PRELIMINARY SITE PLAN FOR VENTURE HOMES
5405 HADAWAY ROAD
LAND LOT 270, 20TH DISTRICT
2ND SECTION

PETITION NO: 2-51

ZONING COMMENTS: Staff Member Responsible: Jason A. Campbell

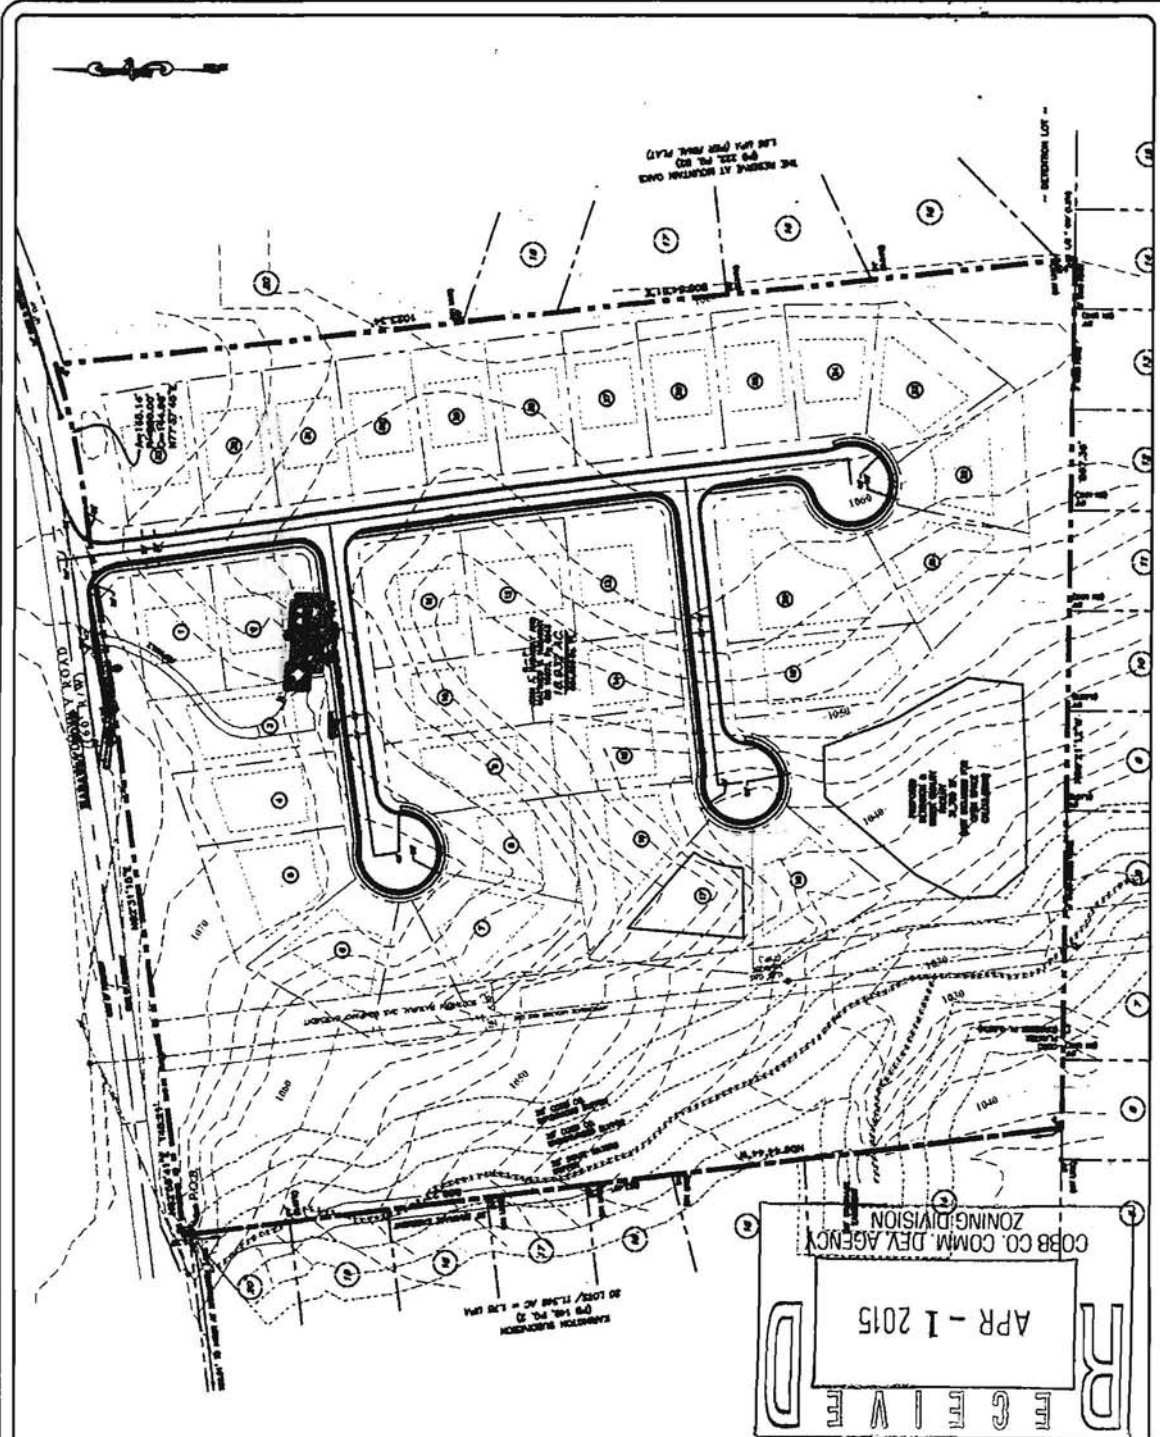
1. As it relates to the variable perimeter buffer (30' to <15') to the rear of lots 24 through 33, open space is considered contiguous when open space elements are connected in minimums of 25 feet in width. Contiguity of open space is highly desirable.

2. Overall residential development shall be compatible with neighboring residential uses. Lots 24 through 33 are listed as some of the smallest lots within the entire proposal and are the closest to larger neighboring residential lots. The plan should incorporate larger lots adjacent to existing neighborhoods with smaller lots designed to the interior.

4. For all lots contiguous to commonly owned open space (lots 1 – 19), staff recommends including a deed that explains that said lots are adjacent to commonly owned Open Space and cannot be disturbed. This is to notify lot owners that there is commonly owned Open Space and it shall remain undisturbed.

5. Recommend fencing or some type of barrier to be installed just on the inside of commonly owned open space and not on the individual lot side of the property. This is to protect open space from land disturbance.

- Provide comprehensive hydrology/stormwater controls to include development of out parcels.
- Submit all proposed site improvements to Plan Review.
- Any **spring activity** uncovered must be addressed by a qualified geotechnical engineer (PE).
- Structural fill _____ must be placed under the direction of a qualified registered Georgia geotechnical engineer (PE).
- Existing facility.
- Project must comply with the Water Quality requirements of the CWA-NPDES-NPS Permit and County Water Quality Ordinance.
- Water Quality/Quantity contributions of the existing lake/pond on site must be continued as baseline conditions into proposed project.
- Calculate and provide % impervious of project site.
- Revisit design; reduce pavement area to reduce runoff and pollution.

- No Stormwater controls shown
- Copy of survey is not current – Additional comments may be forthcoming when current site conditions are exposed.
- No site improvements showing on exhibit.

1. The entire site drains to the south into a small stream channel that flows into the adjacent Westcliffe Subdivision via an existing recorded drainage easement. The site is fairly heavily wooded except for the natural gas easement that traverses the western portion of the parcel and a cleared 2 acre area at the southeast corner of the site. Average slopes are moderate ranging from 5 to 15%.
2. The capacity of the existing culvert under Hurstcliffe Drive must be evaluated to verify no adverse impact to the existing residence at 5535 Hurstcliffe Drive.
3. Adequate screening must be provided between the proposed detention facility and the existing residents within Westcliffe S/D.
4. On-site stream buffers must be verified prior to LDP permitting.

Recommend a deceleration lane on Hadaway Road for the entrance.

Recommend curb, gutter, and sidewalk along the Hadaway Road frontage.

Recommend curb and gutter along both sides and sidewalk along one side of proposed development roadways.
